WIRELESS STATION A510

TECHNICAL HANDBOOK - MODIFICATION INSTRUCTION

Receiver netting

TELECOMMUNICATIONS
F 567 Mod Instr No 2

Fig 1 - Underside view of receiver chassis

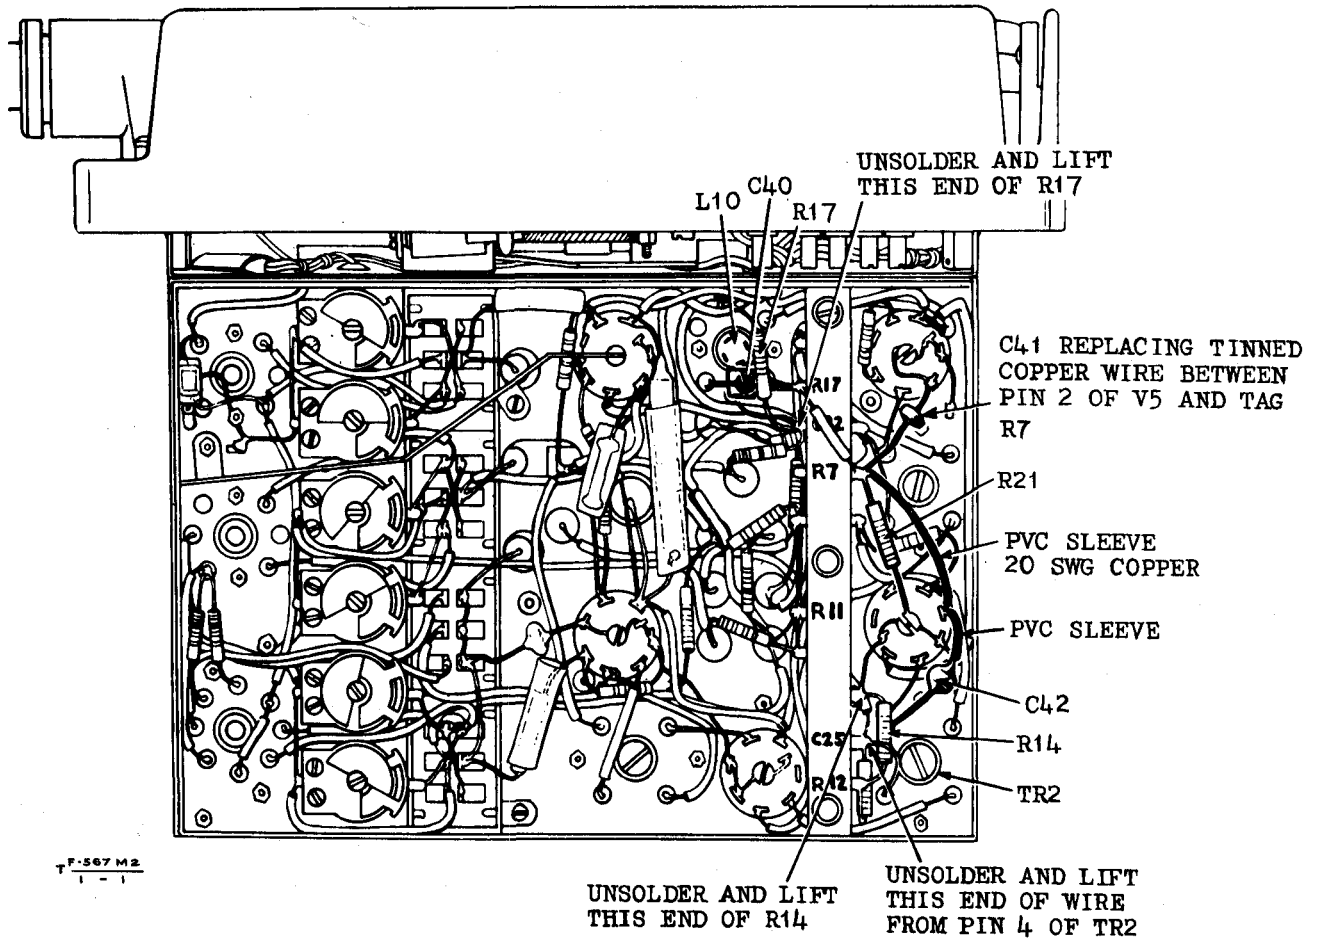
- (b) Locate resistor R17 ($47k\Omega$ $1/2W$) and unsolder and lift that end of it which is connected to the tag marked 'C32'.
- (c) Cover the body of one of the Capacitors, Z/ZA 1756 supplied, with $3/8$ in. of 10 mm P.V.C. sleeving and solder this capacitor between pin 1 (green spot) of the inductor L10 and the tag marked 'R17'. This capacitor becomes 'C40'.

- (d) Solder the floating end of R17 (disconnected at (b)) back on to the tag marked 'C32'.
- (e) Unsolder and remove the wire lead connecting pin 2 of V5 to the tag marked 'R7'.

- (f) Solder the other Capacitor Z/ZA 1756 in circuit between the two points from which the wire was removed at 7(e), ie between pin 2 of V5 and the tag marked 'R7'. This capacitor becomes 'C41'.

- (g) Solder the resistor Z/Z 222130, supplied, between the tag marked 'R7' and the centre spigot of the valve holder V4. This resistor becomes 'R21'.
- (h) Connect the tag marked 'R7' to pin 4 of the valve holder V4 using 20 s.w.g. tinned copper wire insulated by $1.1/2$ mm yellow P.V.C. sleeving.

- (j) Unsolder and lift the wire lead which connects at the tag marked 'C25' (This lead joins tag 'C25' and pin 4 of the second i.f. transformer, TR2). Also, unsolder and lift the earth end of resistor R14.

- (k) Connect the Capacitor Z/AZ 1761, $4.7pF$, supplied, between pin 4 of the valve-holder V4 (covering this lead of the capacitor with $1.1/2$ mm yellow P.V.C. sleeving) and pin 1 (red spot) of TR2. This capacitor becomes 'C42'.

Fig 1 - Location of C109

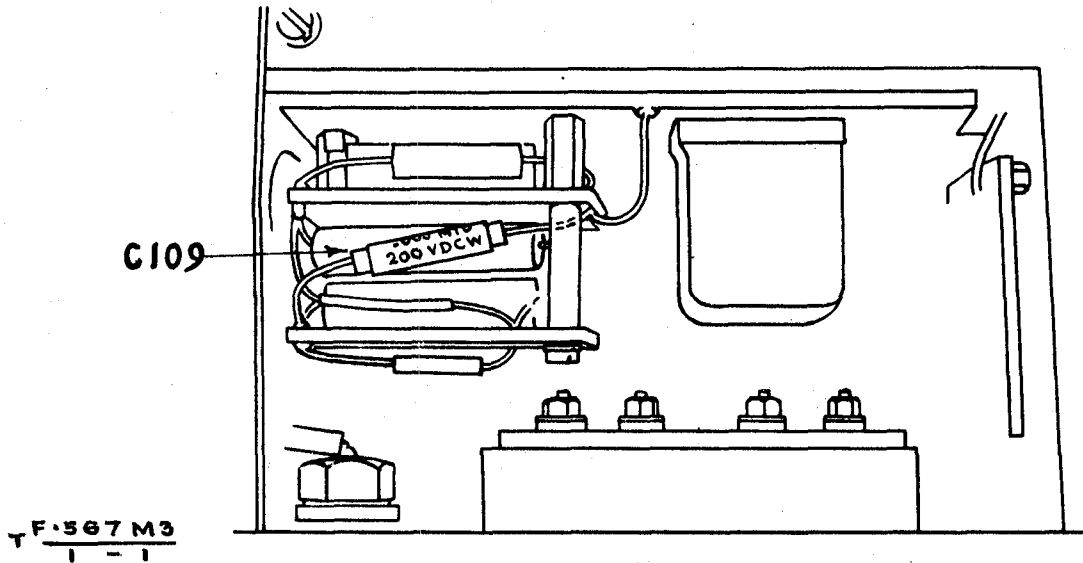
- (b) Locate capacitor C109 (0.001 μ F) (see Fig 1).
- (c) Replace C109 by one of the 0.005 μ F capacitors (Z/Z 115626) provided, connecting one end of the new capacitor to the earth point directly below the spacing pillar and the other end to the top tag diagonally opposite to this earth point. Discard the 0.001 μ F capacitor.

Fig 2 - Location of C111 and C127

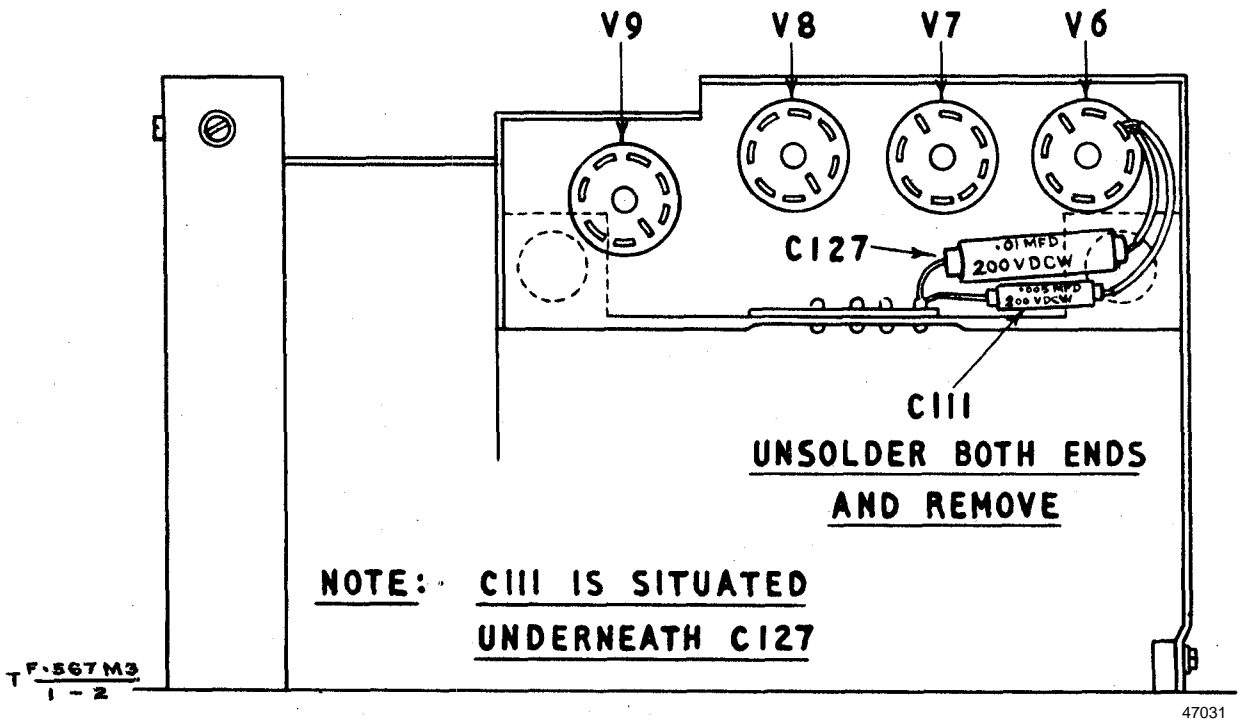
- (d) Locate and remove capacitor C111 (0.005 μ F), which is connected between pin 2 of the valve holder V6 and the terminal plate, and lies underneath capacitor C127 (0.01 μ F) (see Fig 2). Discard the capacitor.

Fig 3 - Capacitor C129 in position

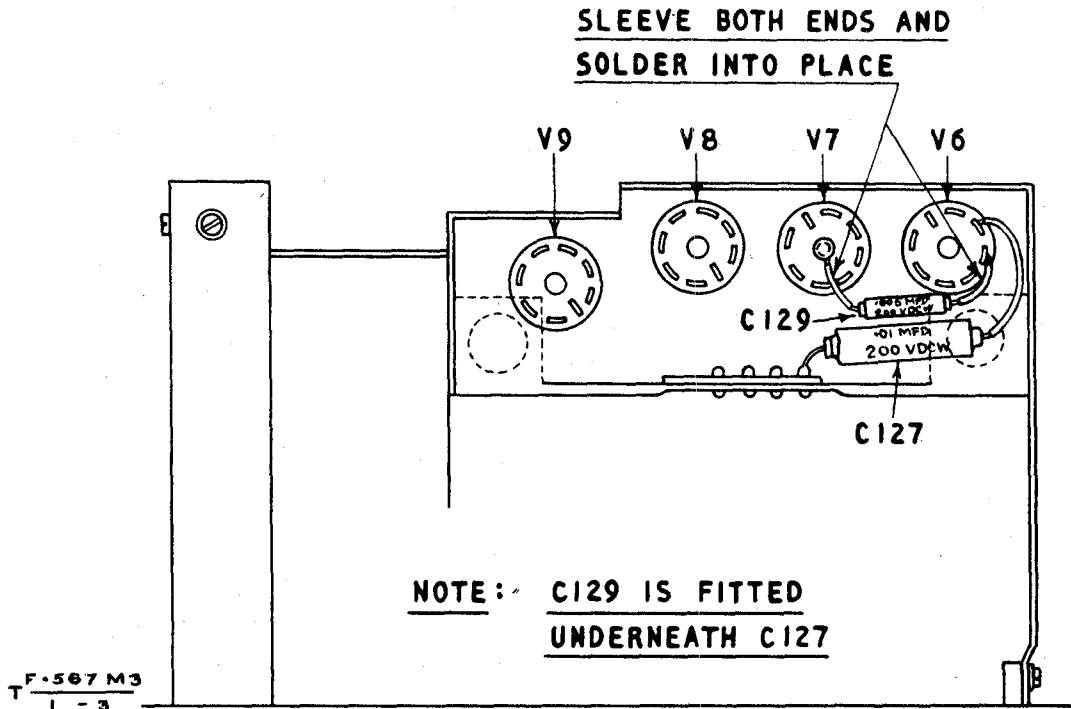
- (e) Place the other capacitor Z/Z 115626 supplied, into the space vacated by C111 and connect it between pin 3 of the valve holder V6 and the earthed spigot of the valve holder V7, after cutting each of the leads of the new capacitor to a suitable length and insulating it with 1.1/2 mm yellow sleeving. This new capacitor becomes 'C129' (see Fig 3).

Fig 4 - Resistor R117 in position

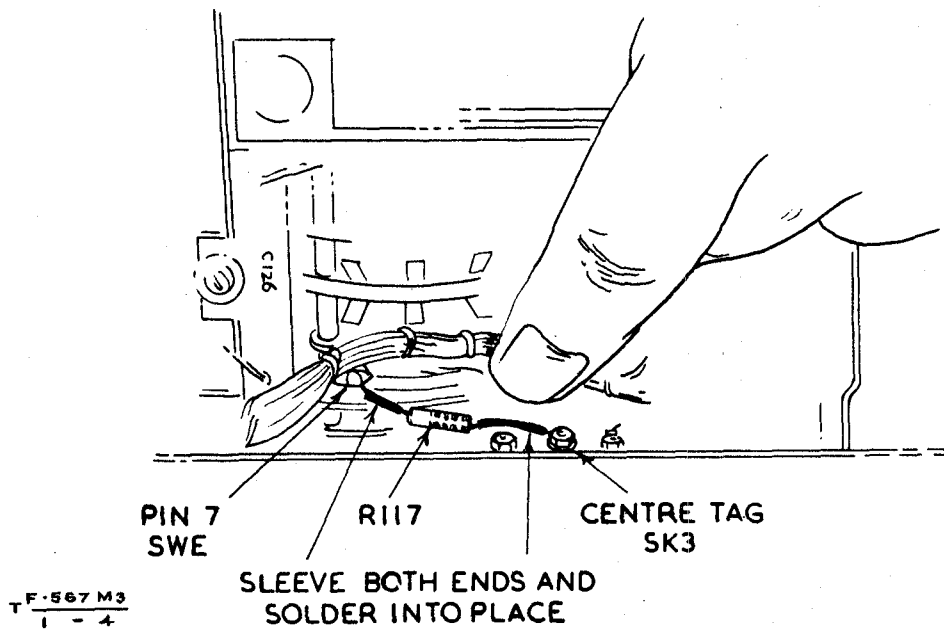
- (f) Referring to Fig 4, locate and remove the lead which joins the centre tag of the 3-point key socket SK3 to pin 7 of the switch SWE. Solder the resistor (220k Ω , Z/Z 223079) supplied, between the same two points ie so that it takes the place of the lead removed. The new resistor becomes R117.
